RFQ NUMBER
 DEFK7044

ADDENDUM #01

ADDENDUM # 1

PROJECT: KINGWOOD READINESS CENTER
Camp Dawson
Kingwood, West Virginia

SHEET NUMBER:
SD-S-001

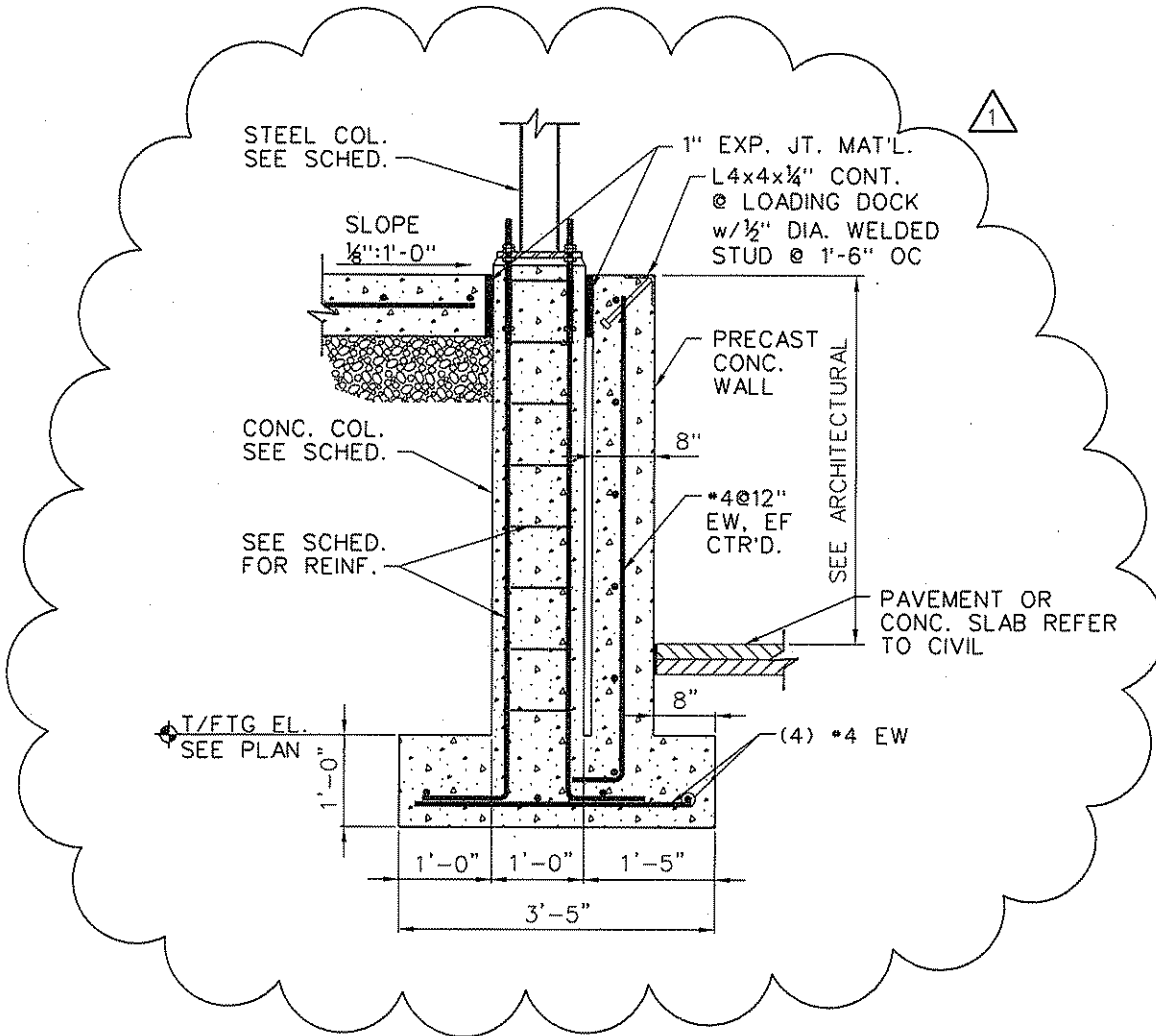
- 01-006: S-303 ENLARGED PLAN & SECTIONS: Delete "Enlarged Partial Foundation Plan" and replace with revised drawing per supplemental drawing SD-S-001.

SHEET NUMBER:
SD-S-002

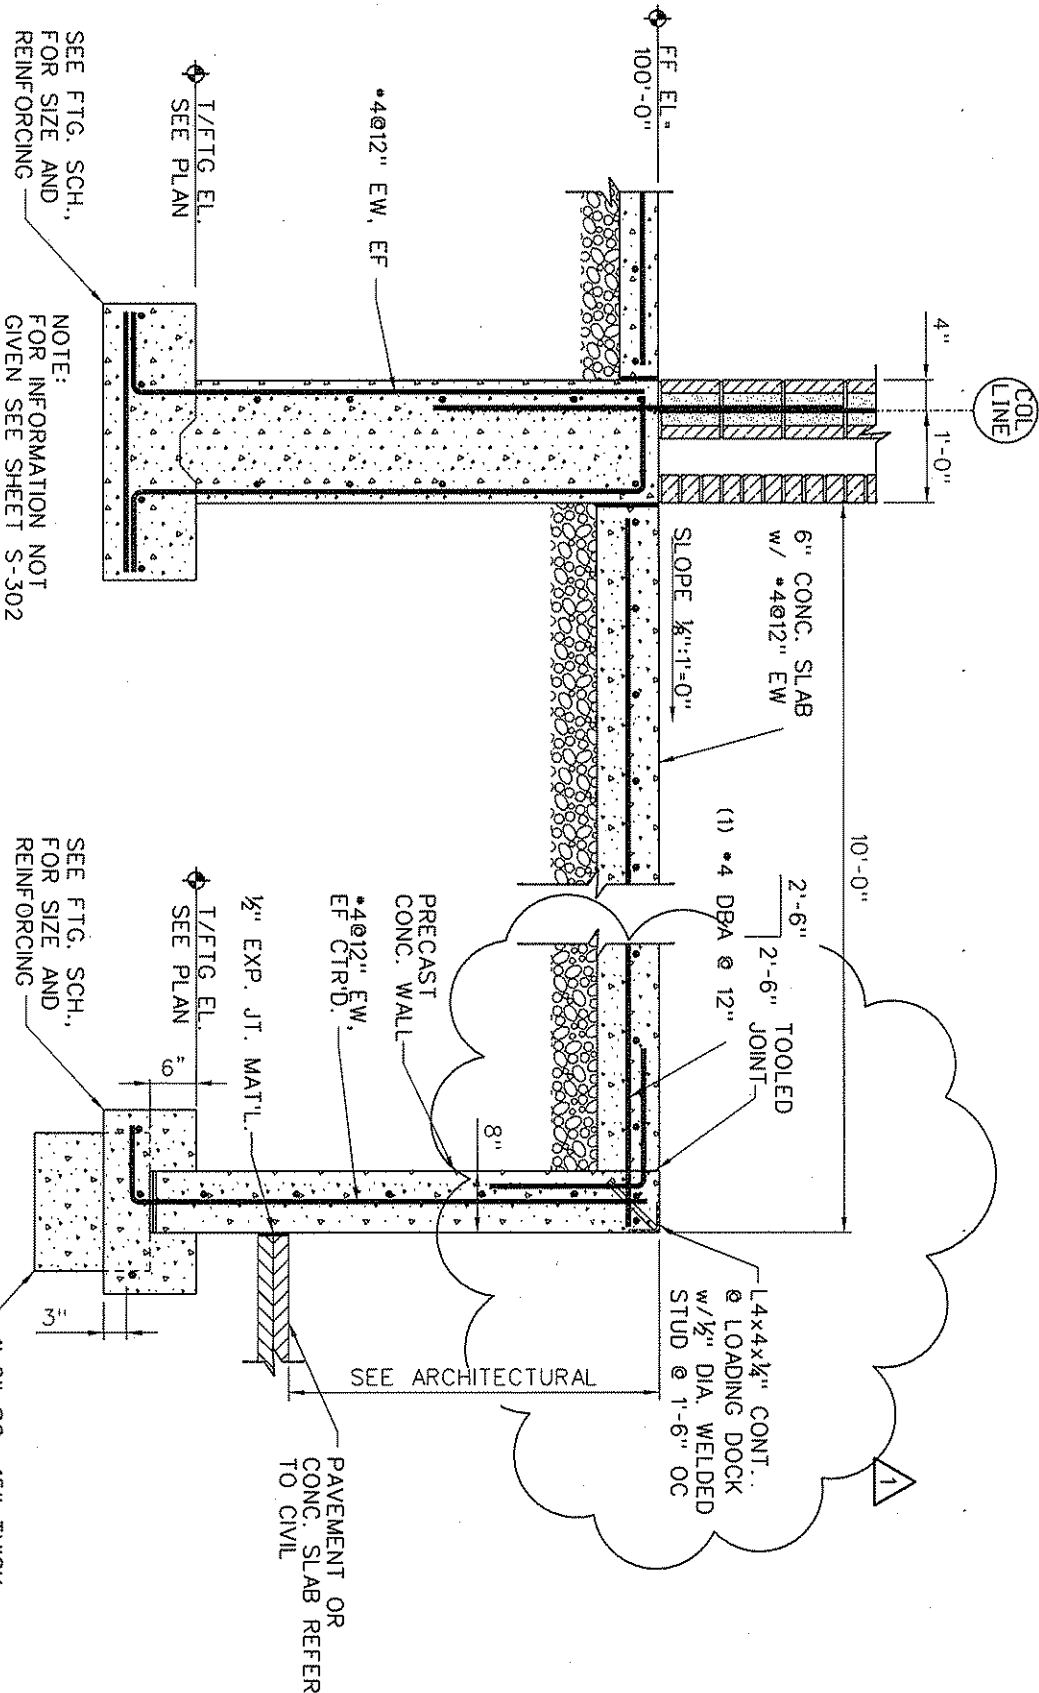
- 01-007: S-303 ENLARGED PLAN & SECTIONS: Add Section E through canopy foundation per supplemental drawing SD-S-002.
- 01-008: S-303 ENLARGED PLAN & SECTIONS: Replace Section A with supplemental drawing SD-S-003.

DESIGNED BY:	DCD
DRAWN BY:	RLL
CHECKED BY:	DCD
REVISION DATE:	08/07/06
SHEET NUMBER:	SD-S-004

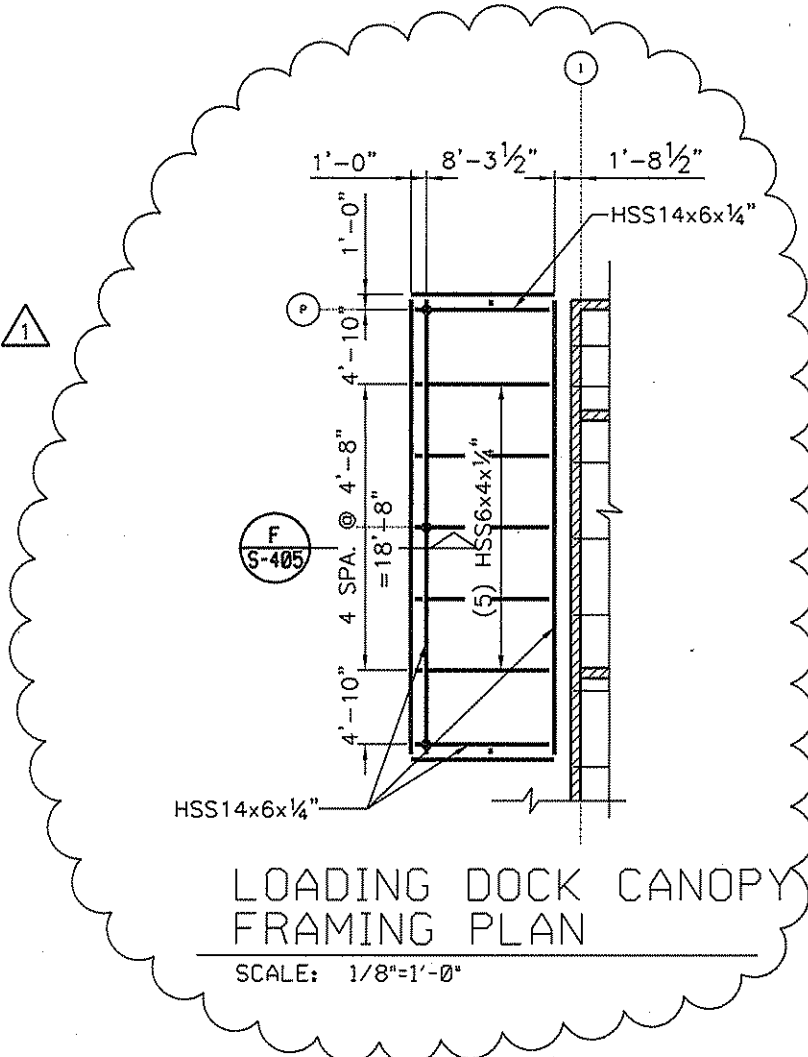
- 01-009: S-303 ENLARGED PLAN & SECTIONS: Replace Section C with supplemental drawing SD-S-004.
- 01-0010: S-130 ROOF FRAMING PLAN: Add "Loading Dock Canopy Framing Plan" per supplemental drawing SD-S-005.

SHEET NUMBER:
SD-S-006

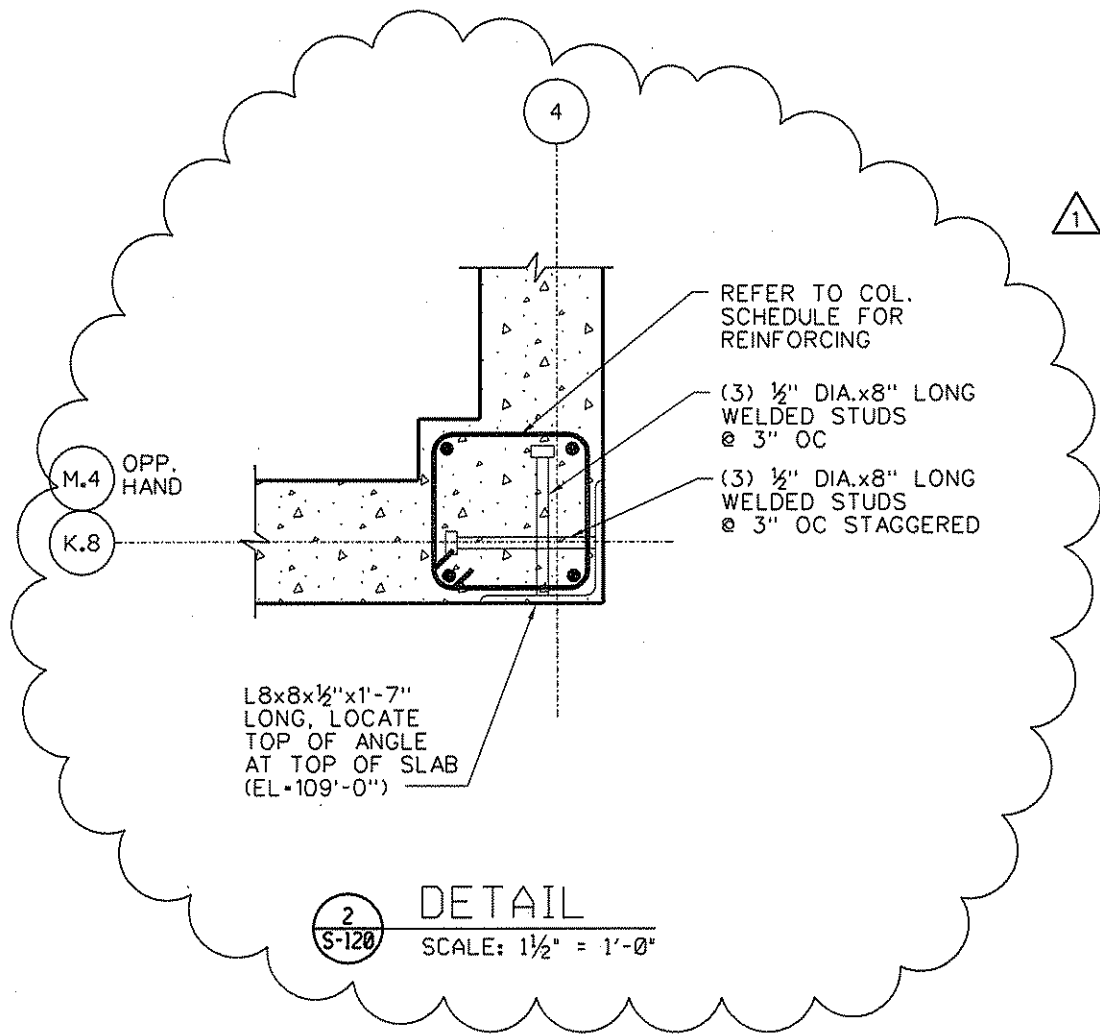
- 01-0011: S-120 MECHANICAL PLATFORM LEVEL FRAMING PLAN: Replace W12x22 with 14K3SP joist to permit ductwork to pass through the joist webs, replace W12x22 with W6x20, replace 10K1 joists with 8K1 joists, add sheet note 8, and change 1/2" plywood to 3/4" plywood per supplemental drawing SD-S-006.

SHEET NUMBER:
SD-S-007

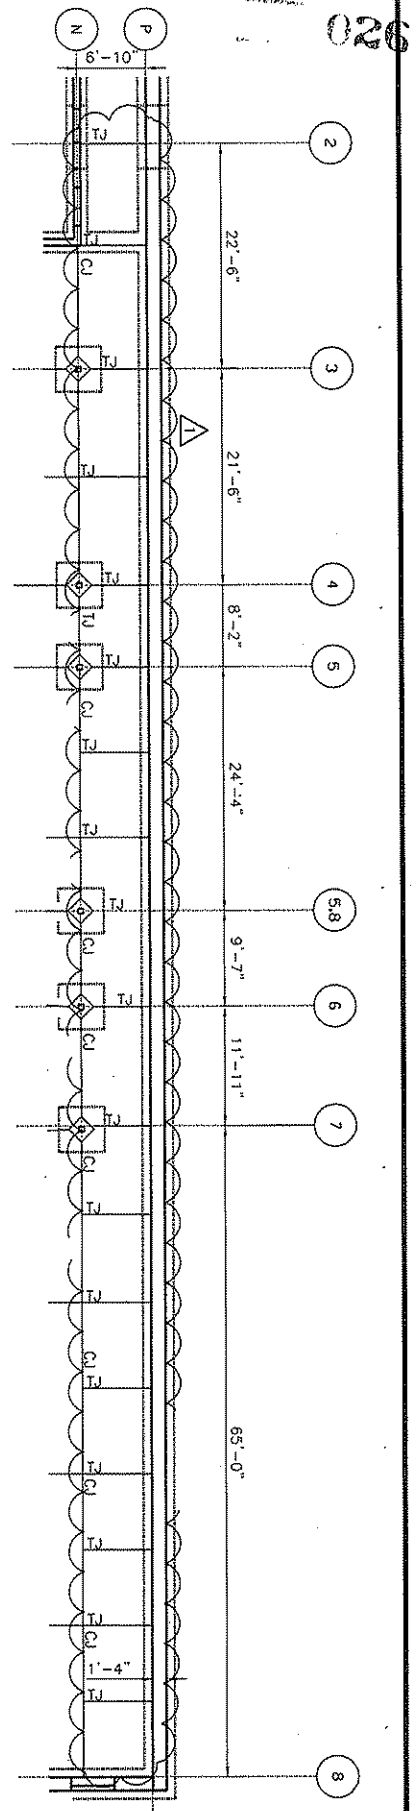
- 01-0012: S-701 VAULT SECTIONS AND DETAILS: Add Detail 2 per supplemental drawing SD-S-007.
- 01-0013: S-110 FOUNDATION PLAN: Replace control joints in hallways 101 and 102 with tooled joints per supplemental drawing SD-S-008.

SHEET NUMBER
SD-A-002

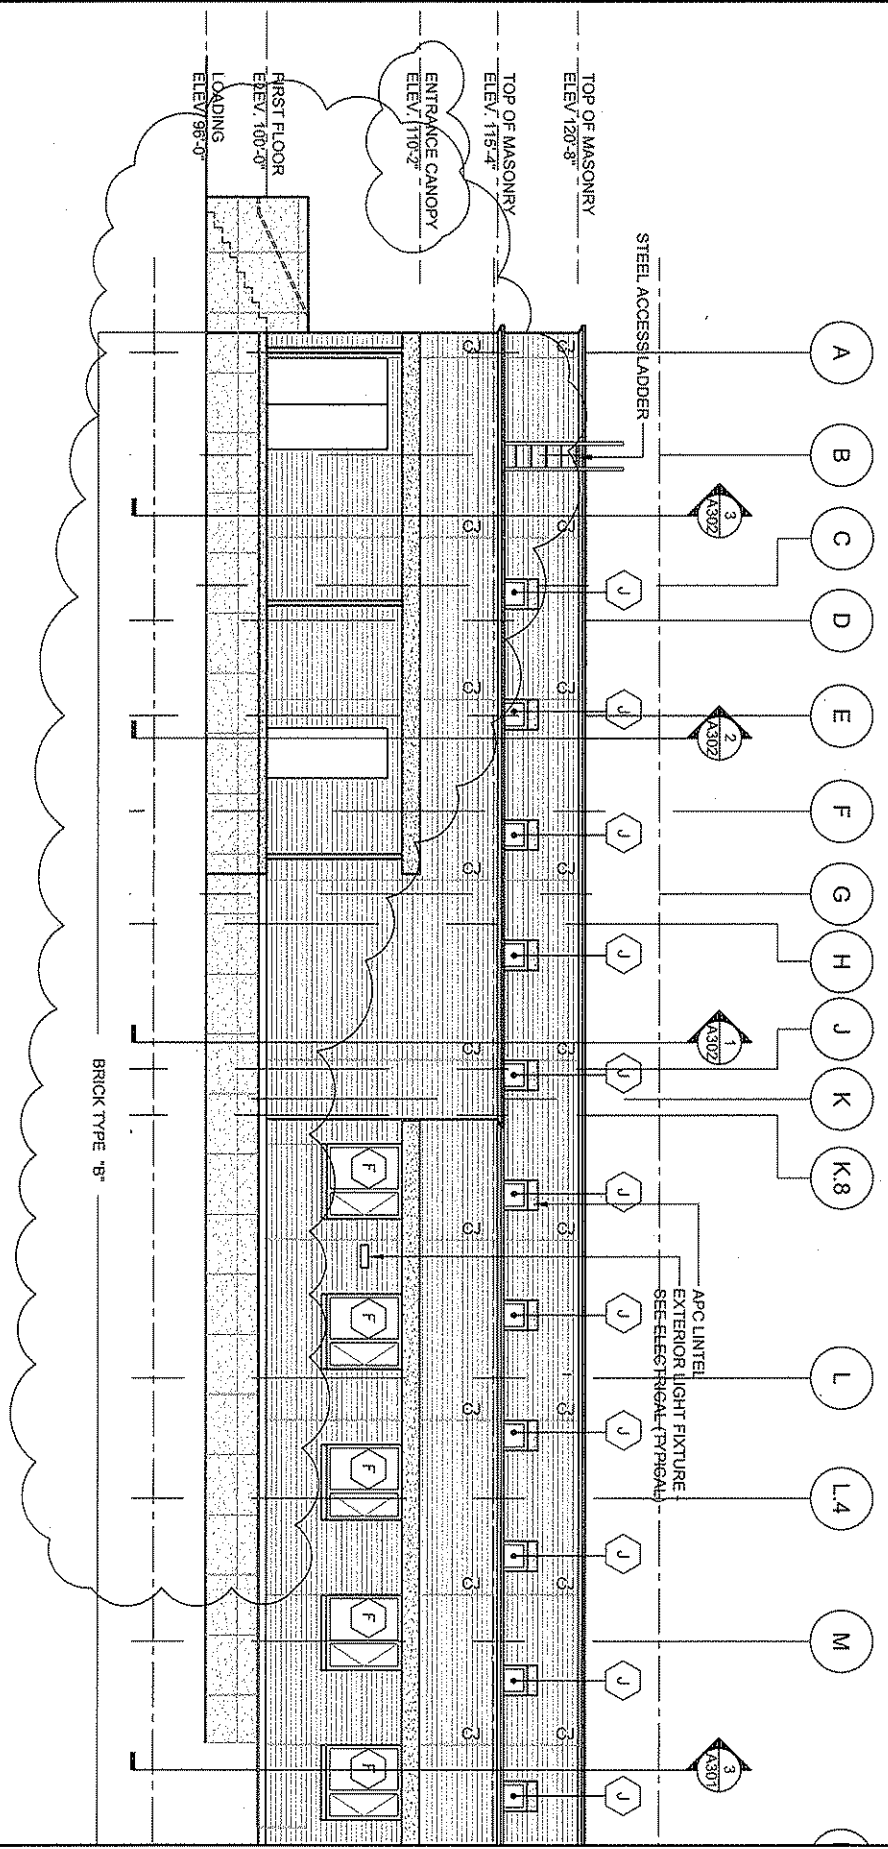
- 01-0020: A200 BUILDING ELEVATIONS: add partial revised 3/A200 SOUTH ELEVATION per architectural supplemental drawing SD-A-002, attached.
- 01-0021: A200 and A201 BUILDING ELEVATIONS: delete Entrance Canopy Elevation at 110'-0" and replace with elevation 110'-2".

SHEET NUMBER:
SD-A-003

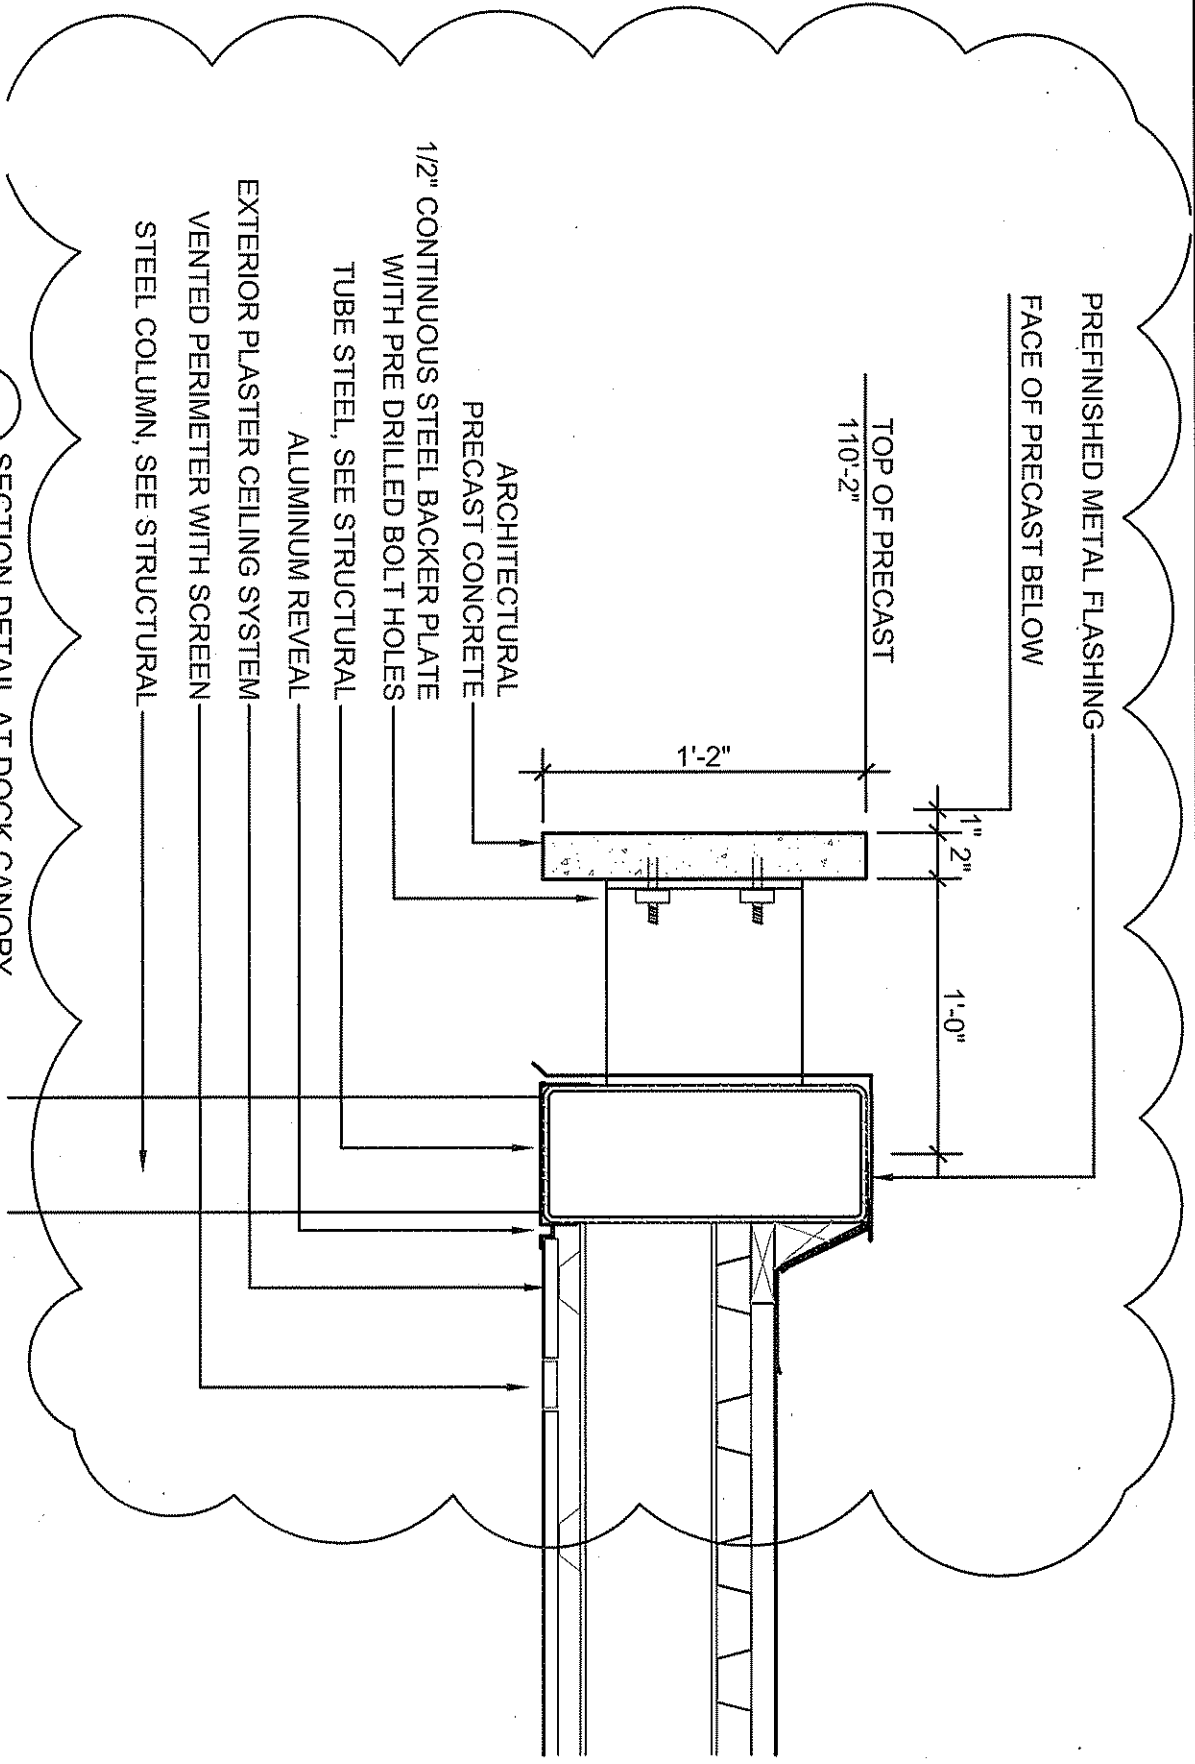
- 01-0024: Delete 1/A315 WALL SECTION and replace with revised wall section drawing per architectural supplemental drawing SD-A-003 attached.
- 01-0025: Delete 4/A512 SECTION DETAIL and replace with revised detail 1/A512 SECTION DETAIL AT DOCK CANOPY per architectural supplemental drawing SD-A-004 attached.
